JZ24-32 FELDMAN KIA PRO

PLANNED REZONING OVERLAY (PRO) AGREEMENT

PLAN REVIEW CENTER REPORT

Rezoning Request from NCC (Non-Center Commercial District) to B-3 (General Business) with Planned Rezoning Overlay (PRO)

ARCHITECTURAL SITE PLAN - SIGNAGE
1/2" = 1'-0"

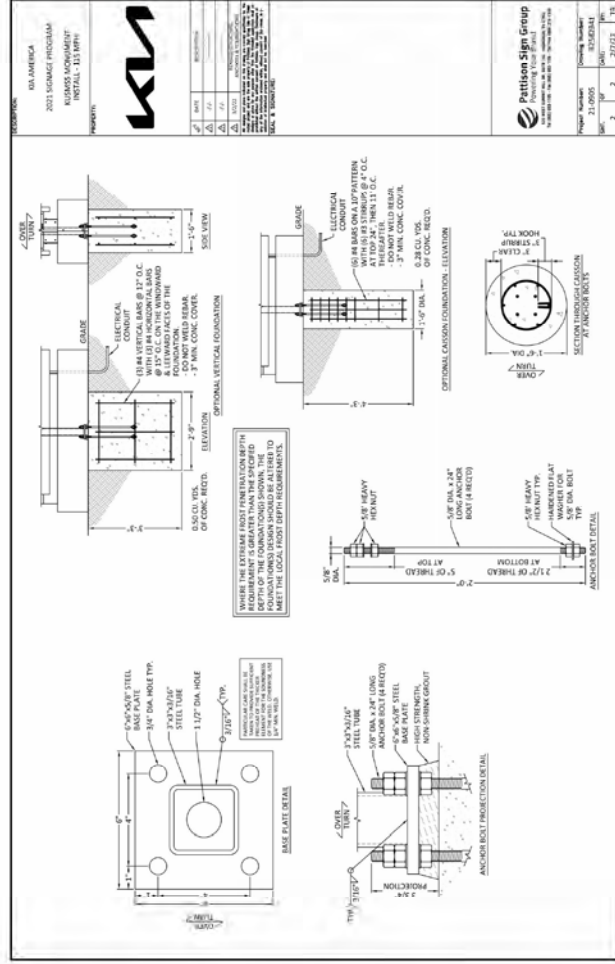
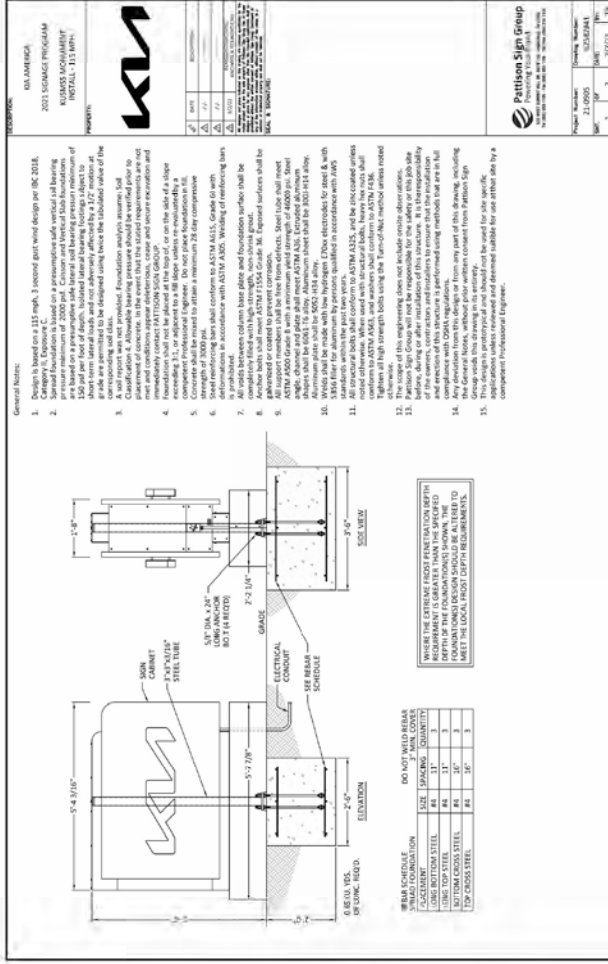
Staff Comment: See staff comments on signage on page 3-4 of this review. The applicant was asked to submit Sign Permit Applications for each sign proposed in order to fully determine the deviations required for the proposed signage.

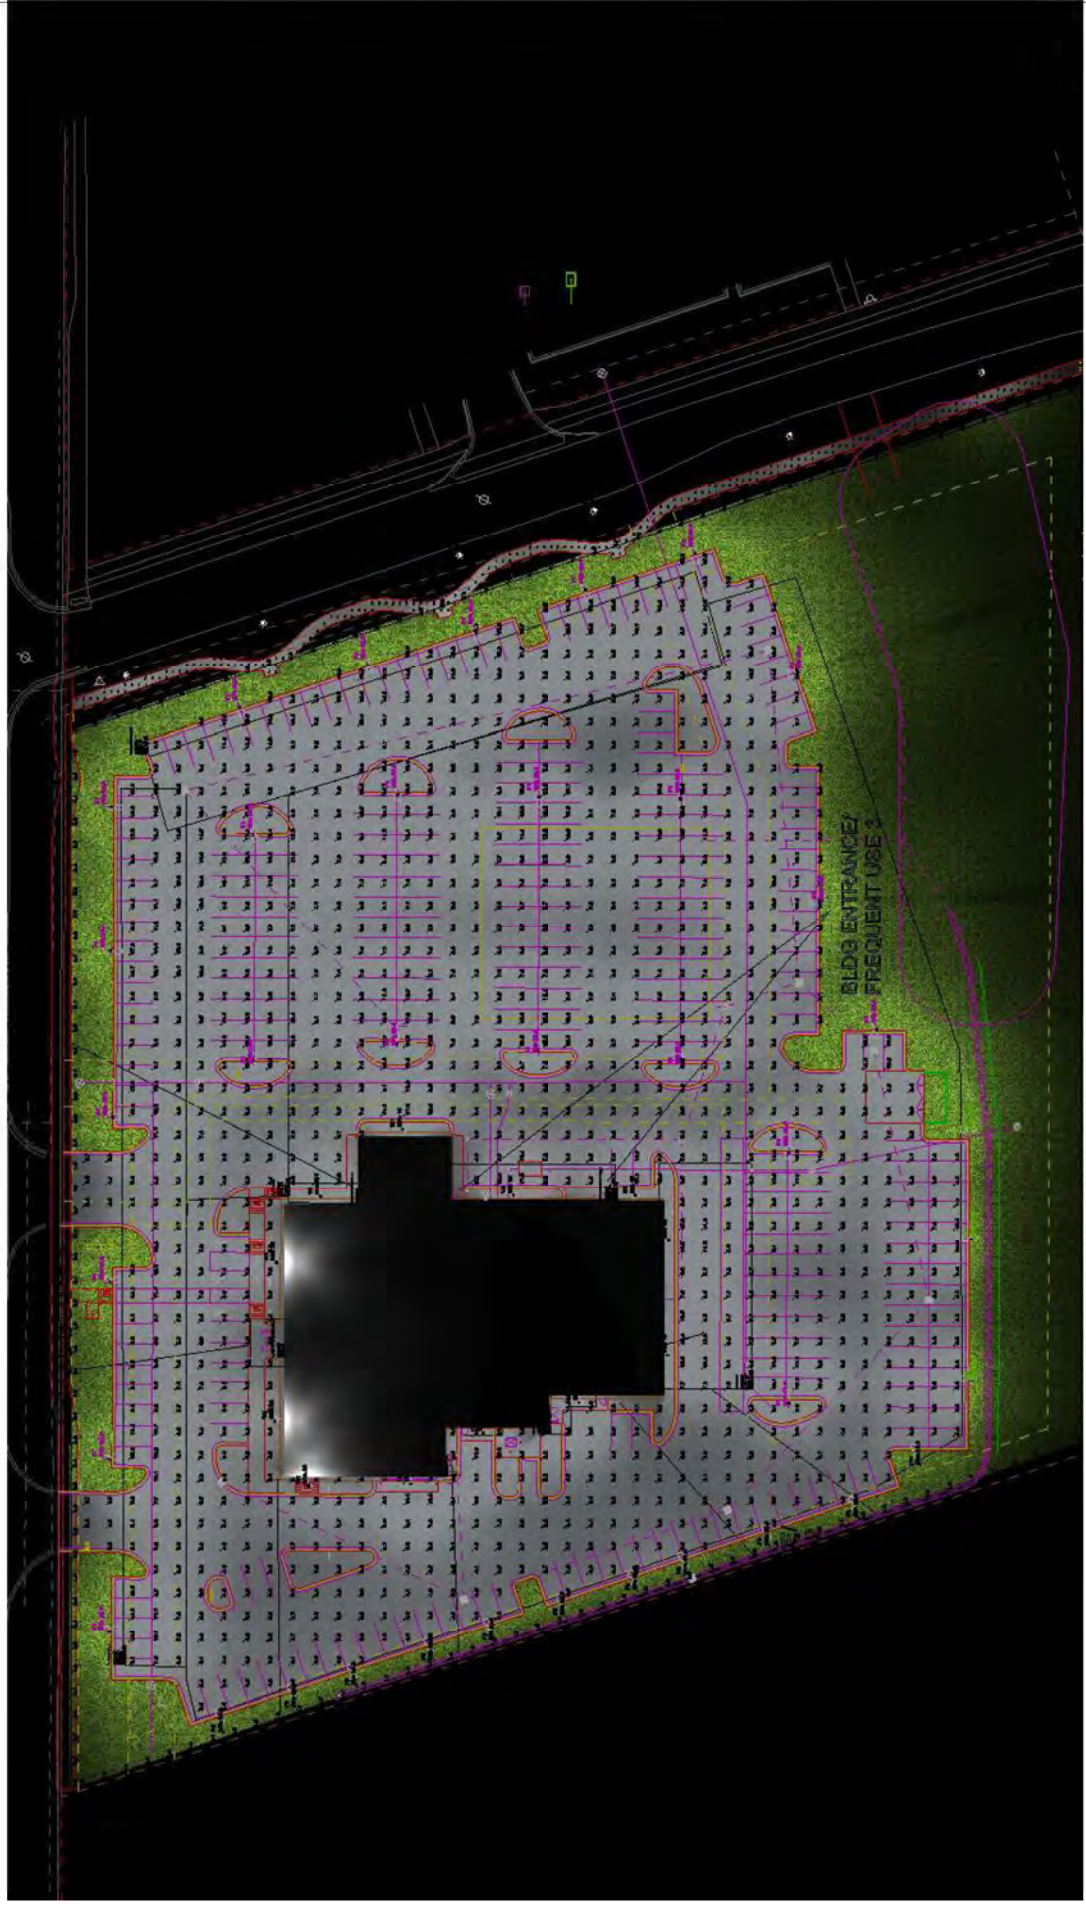
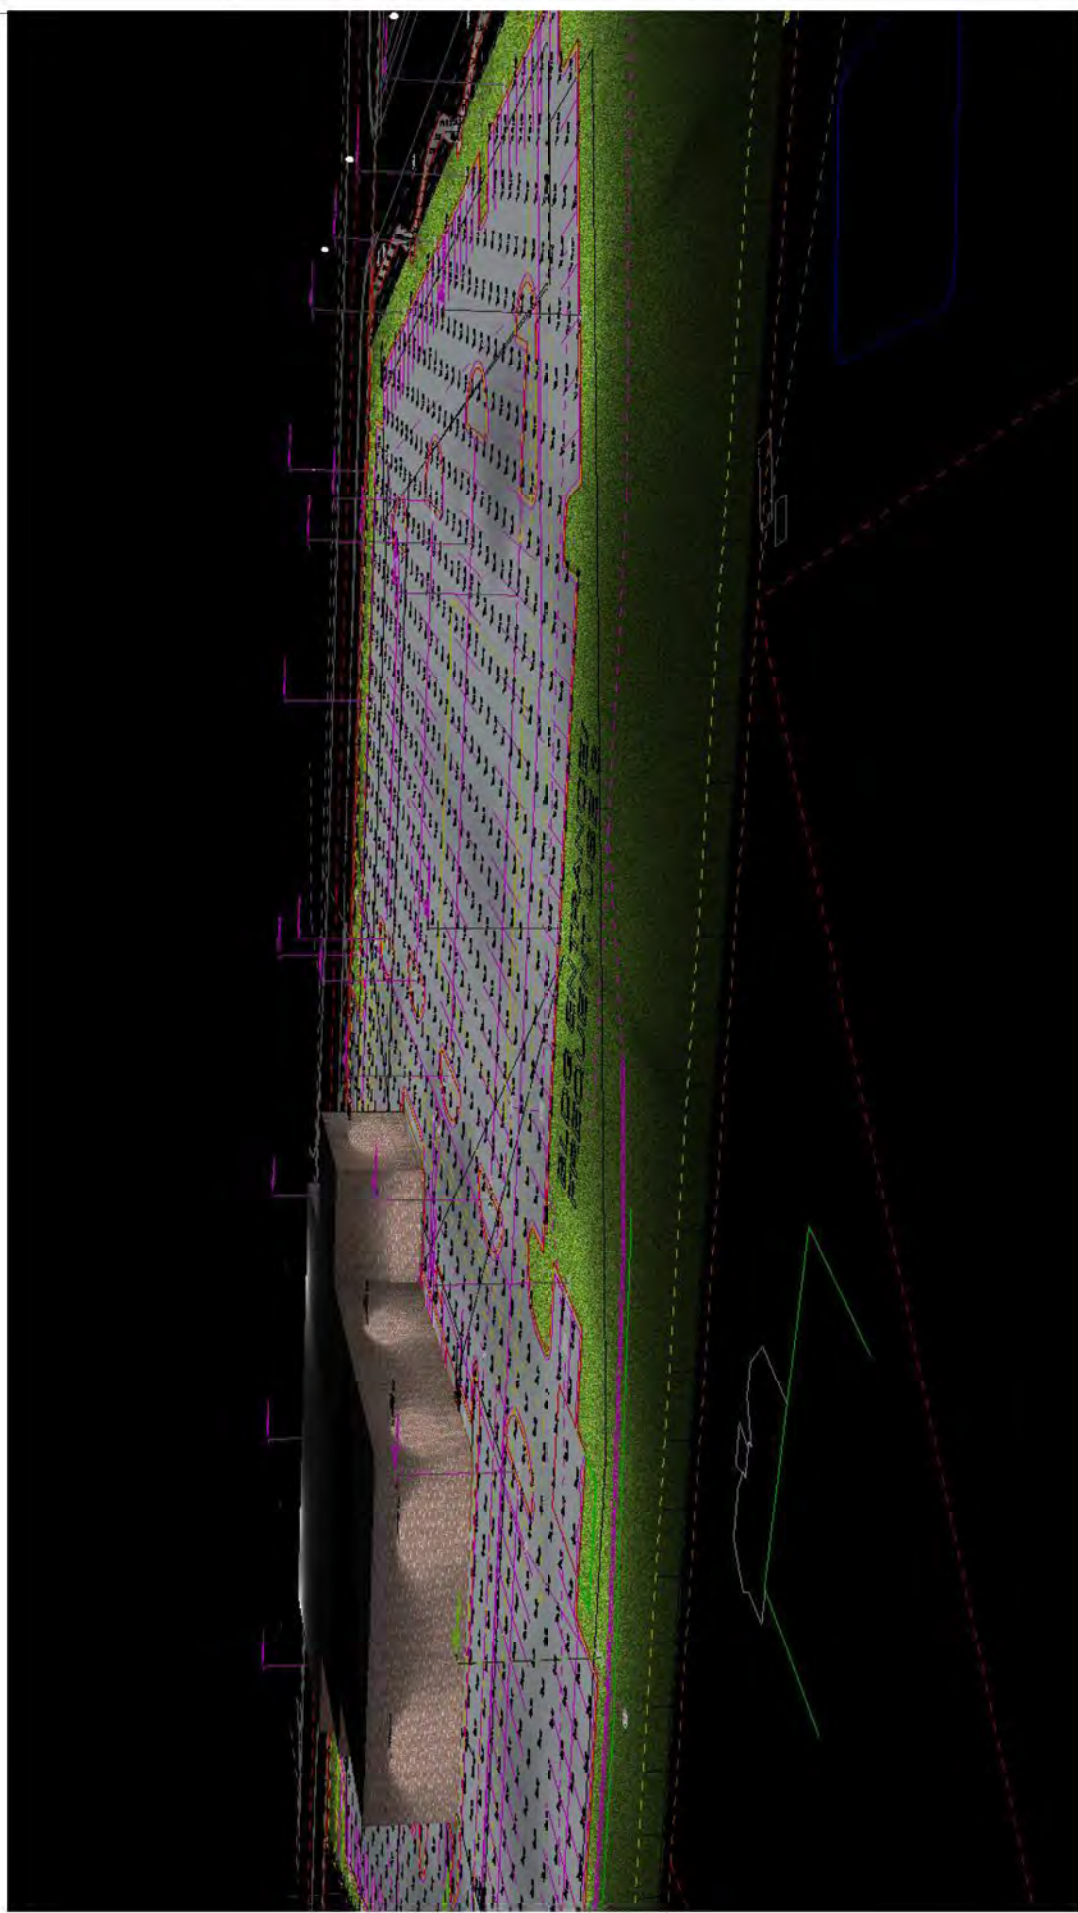
Staff Comment: Sheet L-4 of the PRO Plan shows a total of 3 benches to be provided at intervals along the sidewalk, and includes a detail of the proposed benches and decorative lighting fixtures. The benches and decorative lighting can be considered an enhancement. Providing a sidewalk on the Joseph Drive frontage is a requirement, so the meandering nature of it is the only unique feature, which may or not be considered an “enhancement.”
